EAST ROCKVILLE DESIGN GUIDELINES  
Rockville, Md.

March 12, 2019  
**Draft for Discussion**

**DRAFT FOR DISCUSSION v2**

**Building Orientation (Issue 1)**

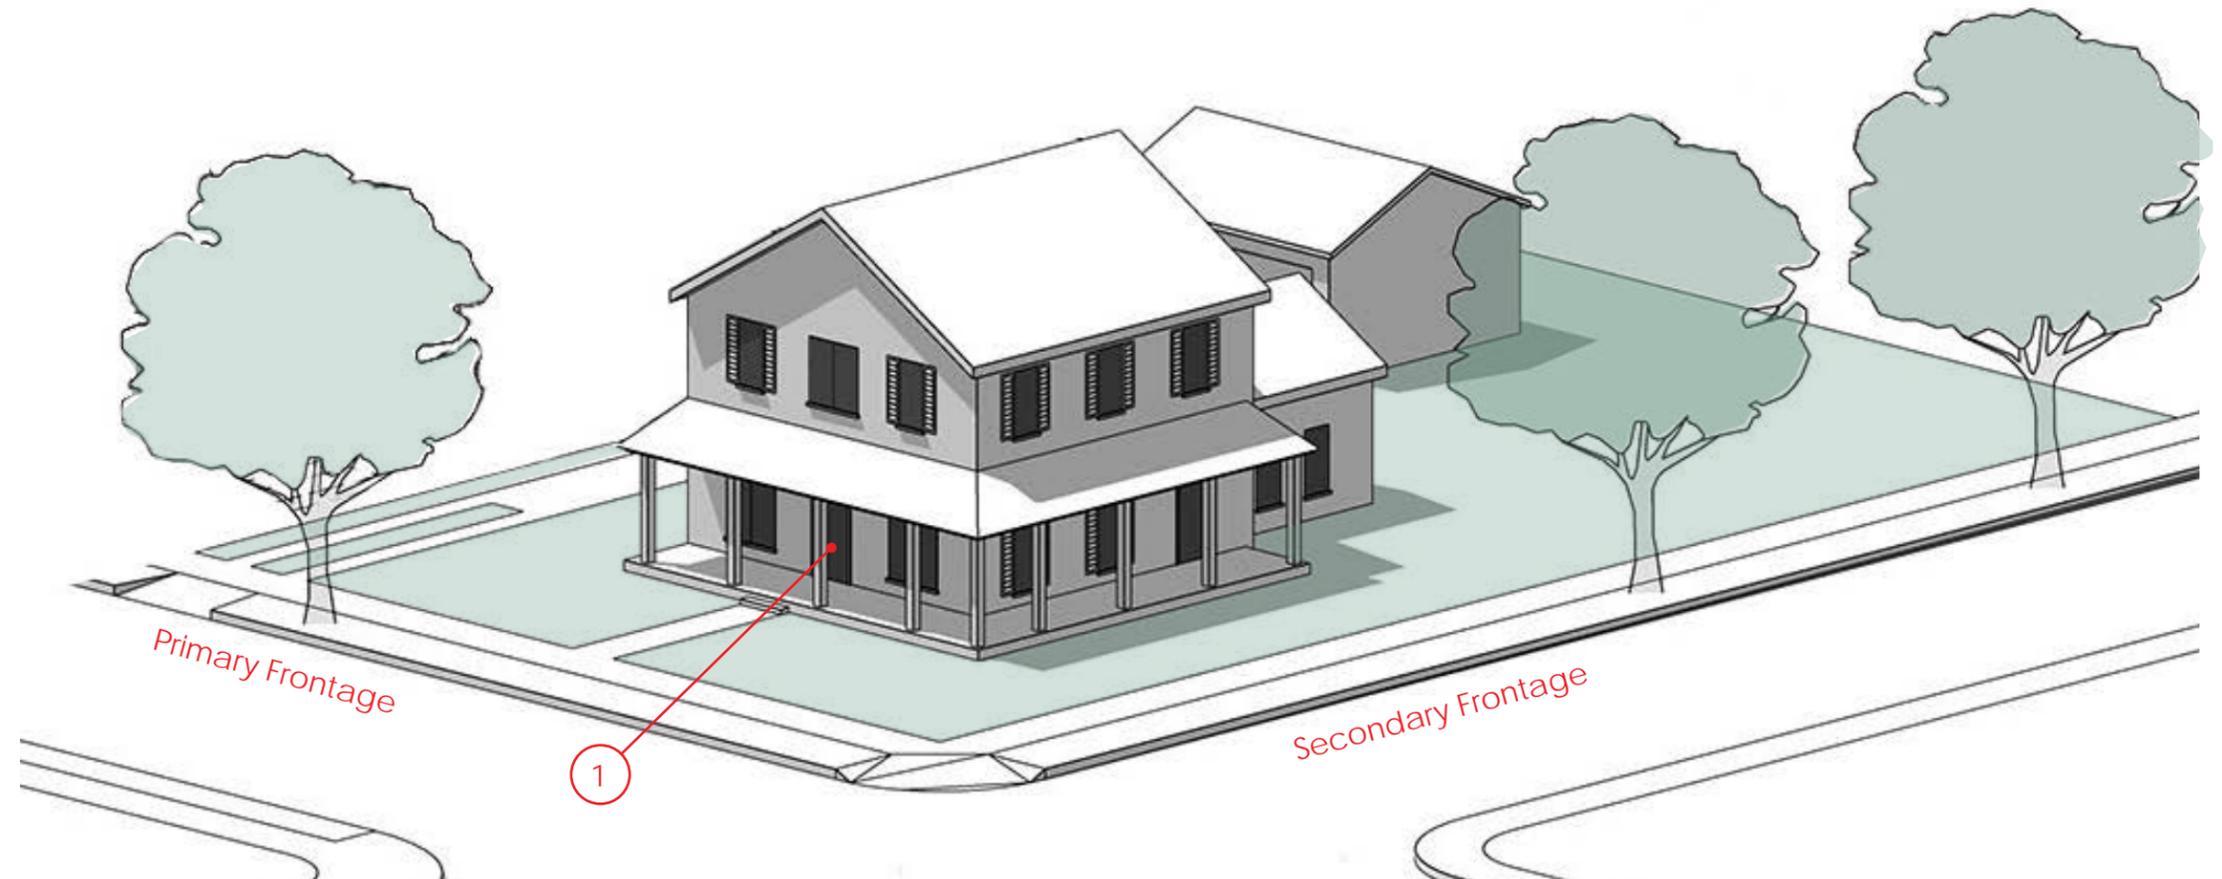
- Please change to "should."
- No comments other than recommending clarification on expectations/ definition of a front door and whether the use of multiple front doors is allowable
- The requirement is only that the front door face the Primary Frontage, there are no other requirements?
- Keep as a shall.
- Edit, for example: The front entrance of the primary building shall face the primary frontage. Add language, ex: Unless based on architectural precedent/fits the historic design of the home.

**Alternative Language**

The front entrance of the primary building shall face the primary frontage.

- In the case of an addition or renovation to an existing house, an exception may be made if the design is based on architectural precedent and the entry placement conforms to the historic or original design of the home.

**BUILDING PLACEMENT (ISSUE 2)**

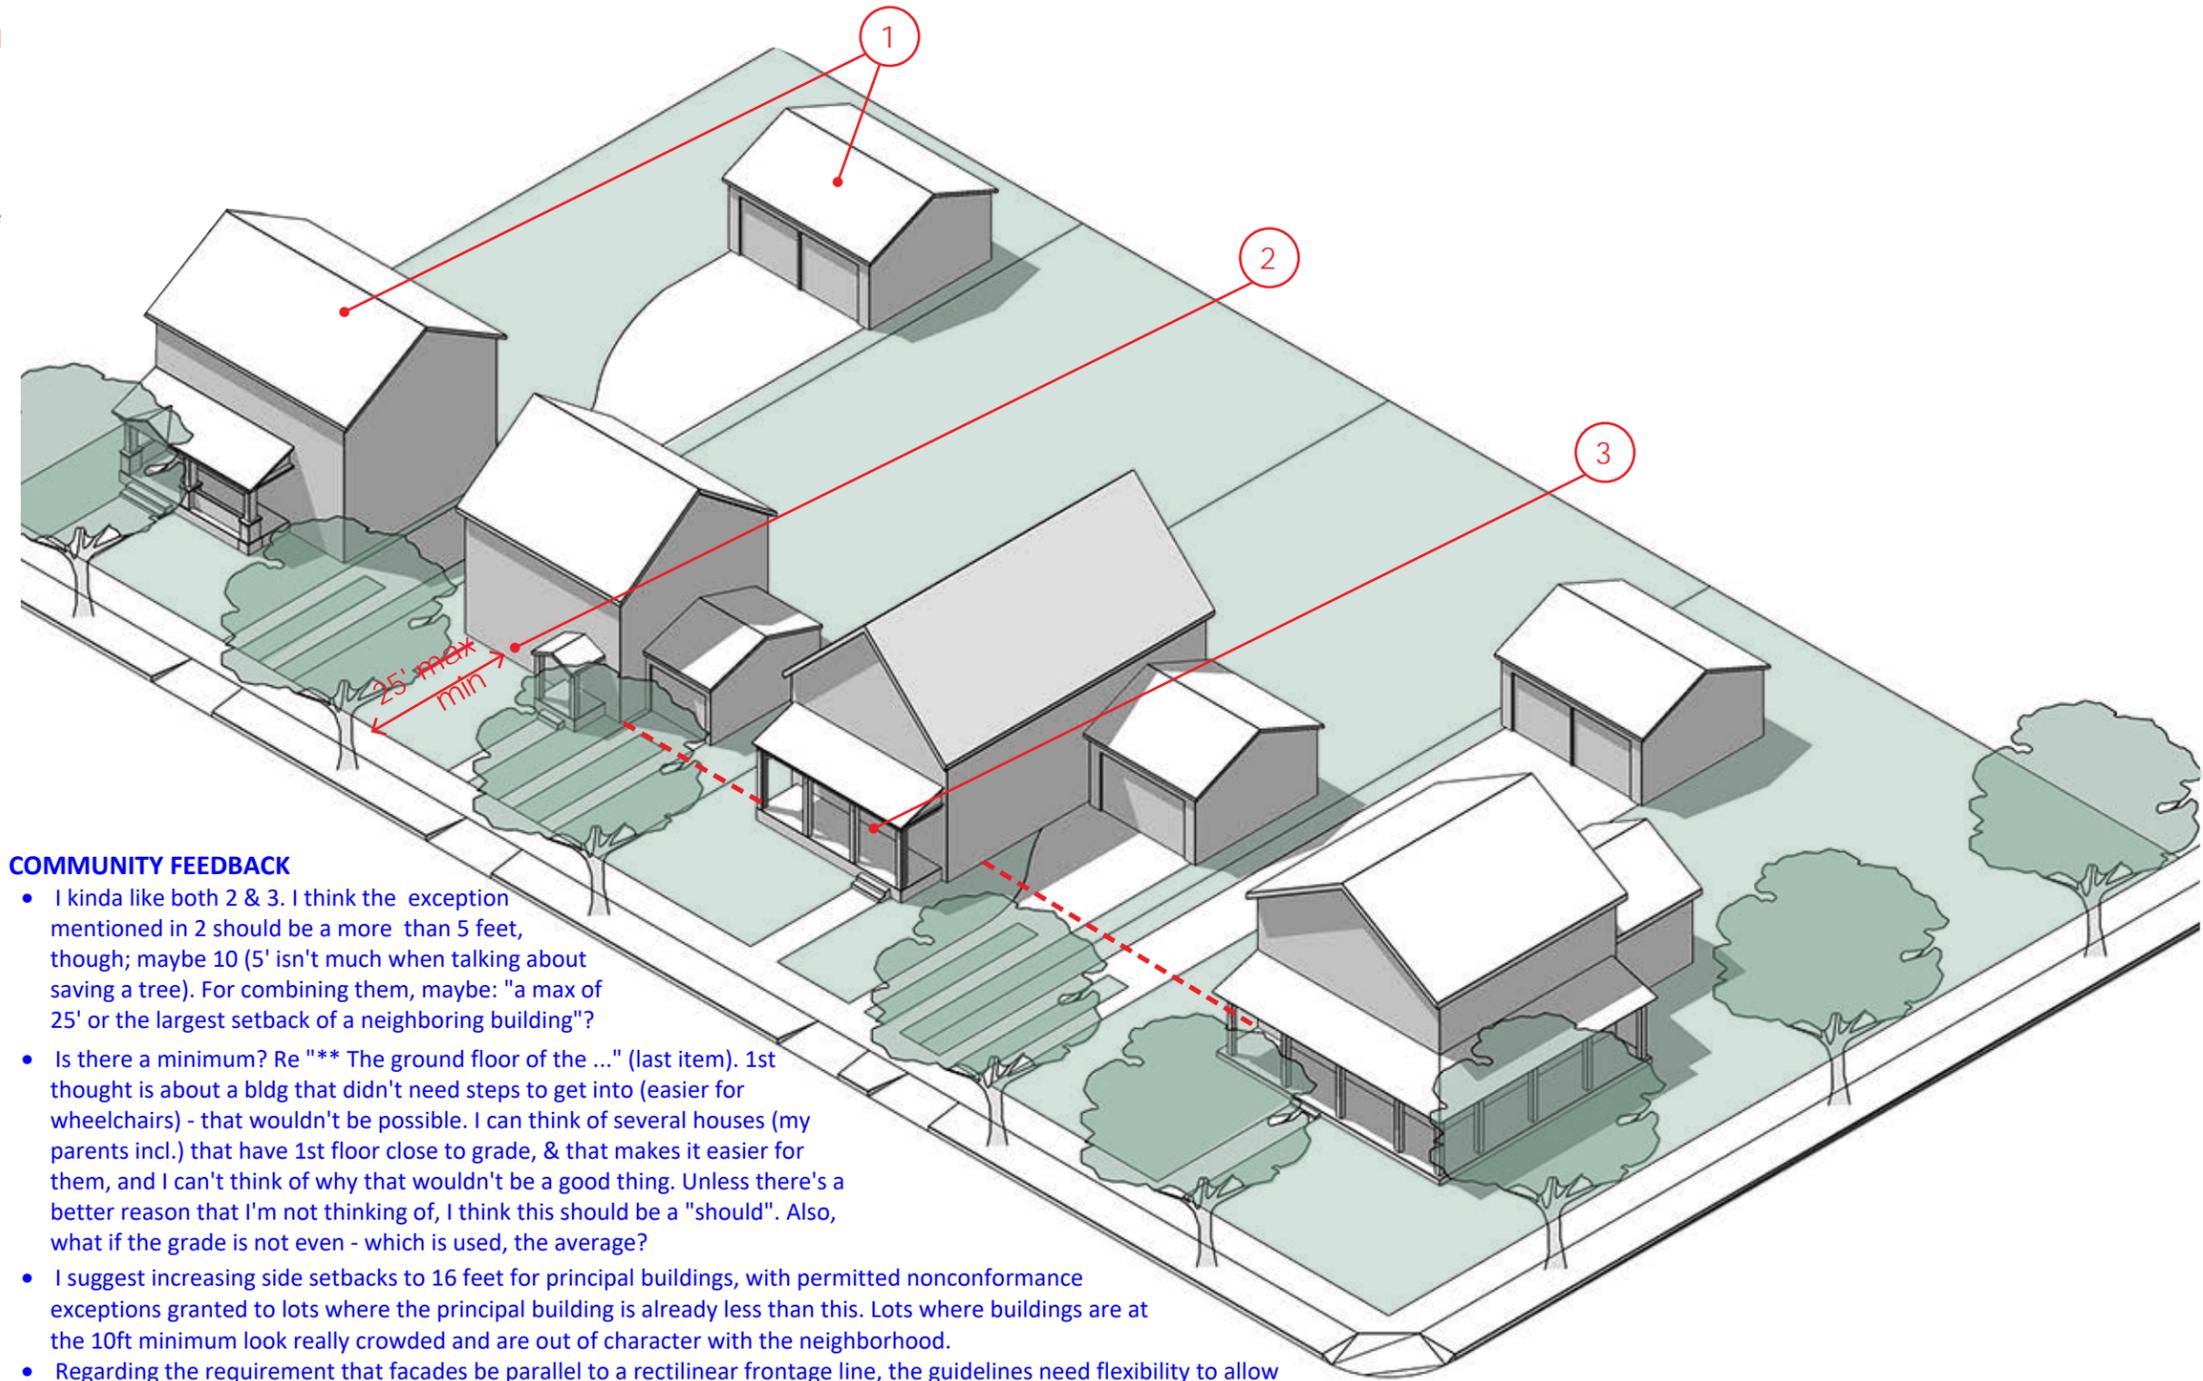
- 3), 5th\*\*: I am uncertain what this has to do with lot placement. I question if this is necessary/useful limitation. A number of houses in the area that make up the existing character of the neighborhood are not raised 2 ft above adjacent grade. Additionally, this requirement creates the need for additional (impervious) ramps in order to make a house handicapped accessible.

- I kinda like both 2 & 3. I think the exception mentioned in 2 should be a more than 5 feet, though; maybe 10 (5' isn't much when talking about saving a tree). For combining them, maybe: "a max of 25' or the largest setback of a neighboring building"?

- Is there a minimum? Re "\*\*\* The ground floor of the ..." (last item). 1st thought is about a bldg that didn't need steps to get into (easier for wheelchairs) - that wouldn't be possible. I can think of several houses (my parents incl.) that have 1st floor close to grade, & that makes it easier for them, and I can't think of why that wouldn't be a good thing. Unless there's a better reason that I'm not thinking of, I think this should be a "should". Also, what if the grade is not even - which is used, the average?

- I suggest increasing side setbacks to 16 feet for principal buildings, with permitted nonconformance exceptions granted to lots where the principal building is already less than this. Lots where buildings are at the 10ft minimum look really crowded and are out of character with the neighborhood.

- Regarding the requirement that facades be parallel to a rectilinear frontage line, the guidelines need flexibility to allow for alternative "modern" architecture.

- Request use of "façades shall be set back a maximum of 12- 25 feet". Please clarify how slope of 10% is calculated for exceptions.
- Item 3, 4th\*\*, the exception for lots w/ slopes may partly address my concern about adding an addition to the front of house - perhaps this point could be clarified as to what such exception would encompass

- Peerless Rockville fully endorses the discussion item on Building Placement that states that facades shall be built parallel to a rectilinear Frontage line or the tangent of a curved Frontage line, and would like this regulation to be included in the next draft of the Design Guidelines

- 1) Primary frontage? What if there is a secondary frontage? Would a second building on frontage be allowed? it is a completely different view line.
- In General on this page: what about corner lots in terms of setback? Does it provide any flexibility for the secondary frontage, or will it follow the same rules as primary frontage?

- 2) a Shall with exceptions, could perhaps become a should, with a Shall range. I.e.: Façades Should be set back 25 feet from the front lot line. and Shall not be less then 10 ft or more then 35 feet. (Exact distances tbd, used as example). In that case, it provides for flexibility that is described for both an additional distance due to tree, as well as positioning between other houses.

- We need a minimum [front setback]. Homes built right up on the sidewalk are too urban and make it too hard to maintain the canopy.

Lot Coverage (Issue 3)

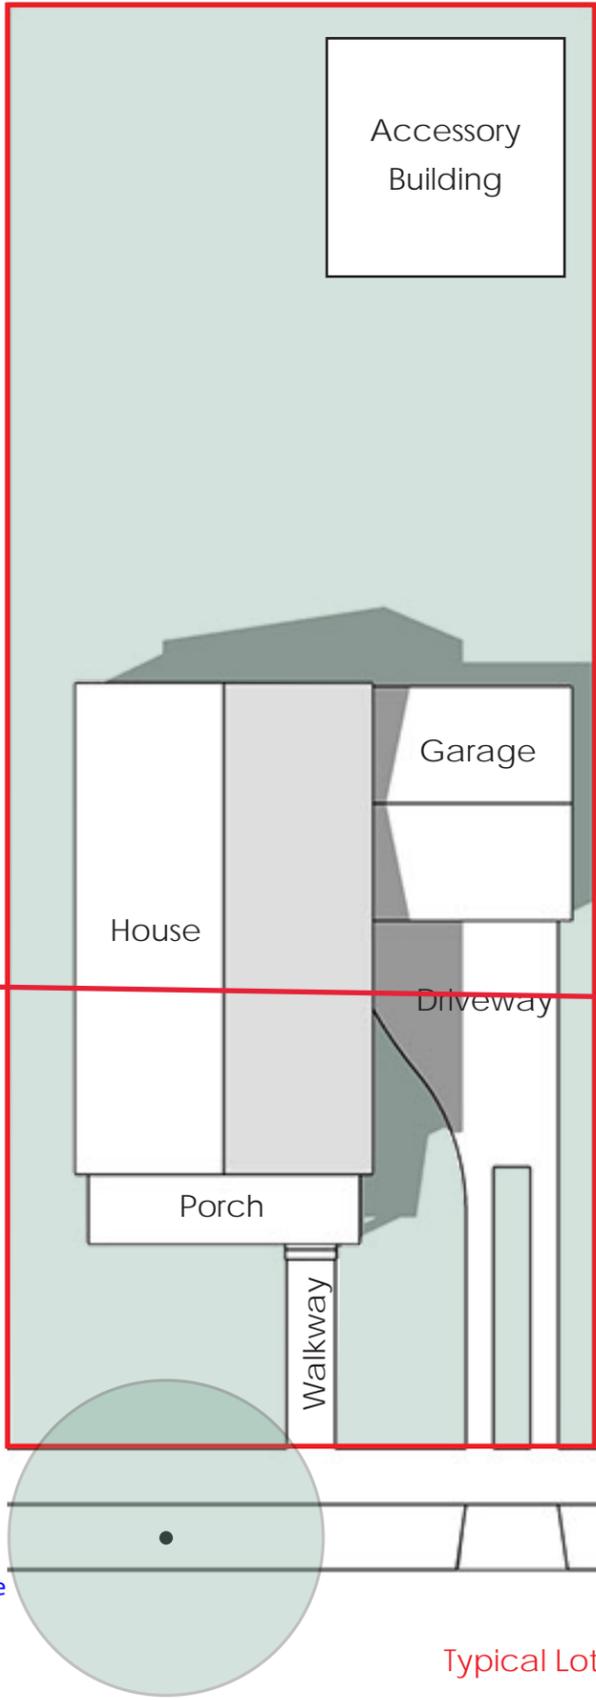
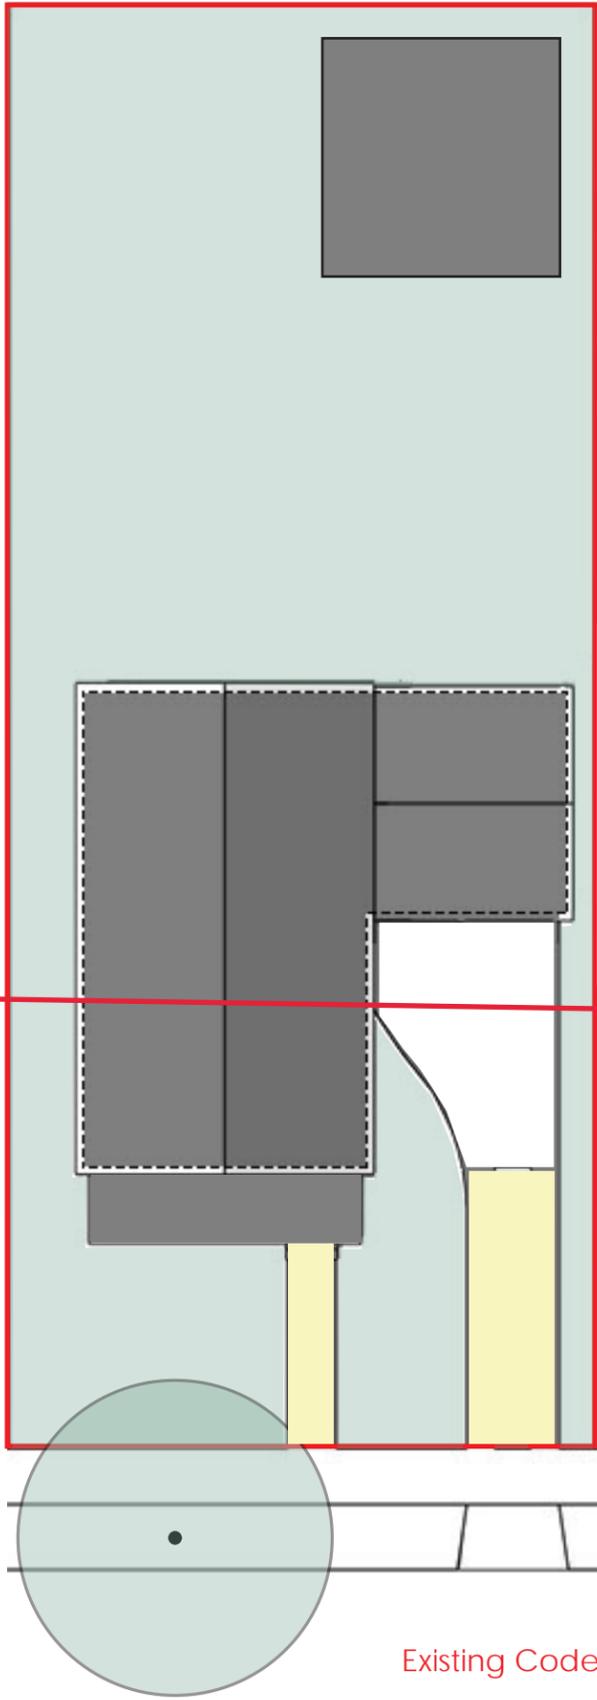
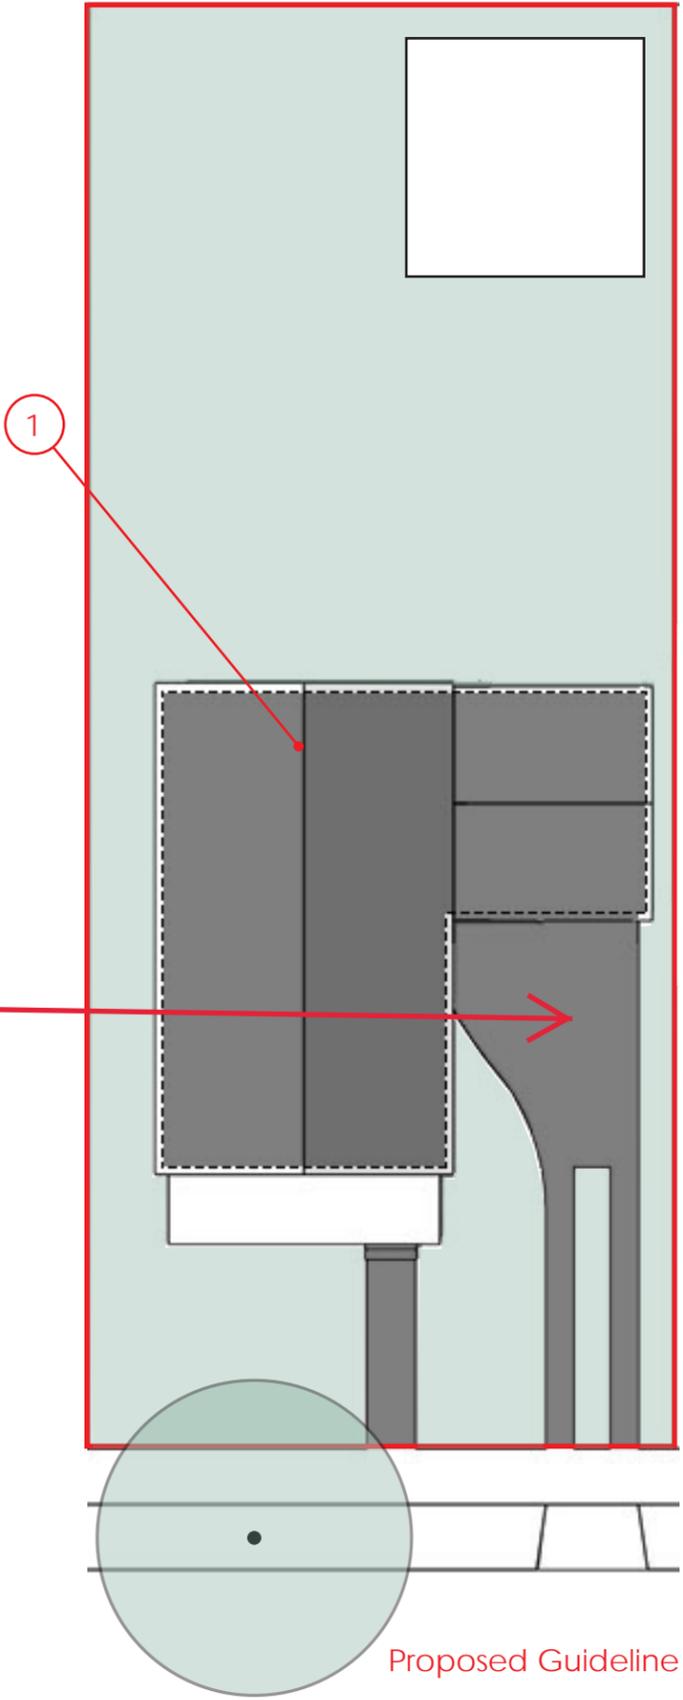
- I'm uneasy about excluding the "Accessory Building". The way it is defined, I think that allows sheds and garages (as opposed to "living in" buildings. I think it was said in the meetings that the desire was to encourage Accessory Dwelling Units, but this seems to say garages, too. I'm not even sure I want Accessory Dwelling units excluded (but I think that'll be dealt with outside of our scope), but I definitely don't think sheds/garages should be excluded.

- I understand the desire to avoid exceedingly large new construction that appears out of proportion to smaller existing homes in the neighborhood, but then again, many lots in East Rockville are quite small, and in my opinion, the allowance for lot coverage percentage should be more generous.

- I suggest counting ADUs in the 35%. Otherwise, you create a huge loophole.
- Need to clarify on the definition of "impermeable surface." Concrete pavers: Permeable or impermeable surface?

- Need clarity on the definition of "dwelling unit" to avoid gaming with the exception (e.g. claiming that a garage is a dwelling unit).
- Table on next page says driveway pavement must be "pervious" so this illustration appears inconsistent with proposed guidelines.

- Recommend allowing exemption of primary walkway as well. In addition, recommend allowing caveats for land coverage percentage based on lot size. For smaller lots (defined by the city) allowing up to 40% coverage.

- I'm sure the 35% restriction was discussed before I arrived - if I understand it the restriction would not include an additional dwelling structure (whether attached or freestanding?)

- Make a distinction between maximum lot coverage by (vertical) structures (such as houses, sheds, accessory buildings, carports, etc) and a maximum lot coverage for flat impermeable surfaces. I suggest that the total coverage cannot be more than 45%, and that the coverage by vertical structures cannot be more than 30%. If no distinction is made, I suggest to raise the maximum lot coverage area to 45%.

- We [Peerless] do question the proposed exclusion of ADUs from the 35% lot coverage max. East Rockville is historically a neighborhood of SF residences and ADUs are not currently legal. While additional zoning regulations may be generated to apply to ADUs, excluding them from the Guidelines provides an opportunity for a proliferation of these structures without the careful regulations applied to the main dwelling.

- When is landscaping a path, that needs to get counted, and when not? if- for the purpose of preventing run-off, A walkway arguable has a limited impact as impervious area. - Could it be "any impervious surface over 4 or 5 ft wide is to be included? Additionally- not counting ADUs concerns me, especially with the aim of expanding accessory bldg use to the potential of accessory dwelling.

- We appreciate the gesture of porches being excluded from building footprint, and limiting driveways - However, we do not believe this is the right way to go about it. We see potential complications with pathways and landscaping, or a terrace (Which, in our understanding will also be counted as lot coverage?) There also seems to be a discrepancy between goals with this page, and the page requiring minimum of 2 cars to be parked on driveway.

- Yes on open porch! Could someone put a 500 SF porch on a house? Love encouragement for pervious cover.
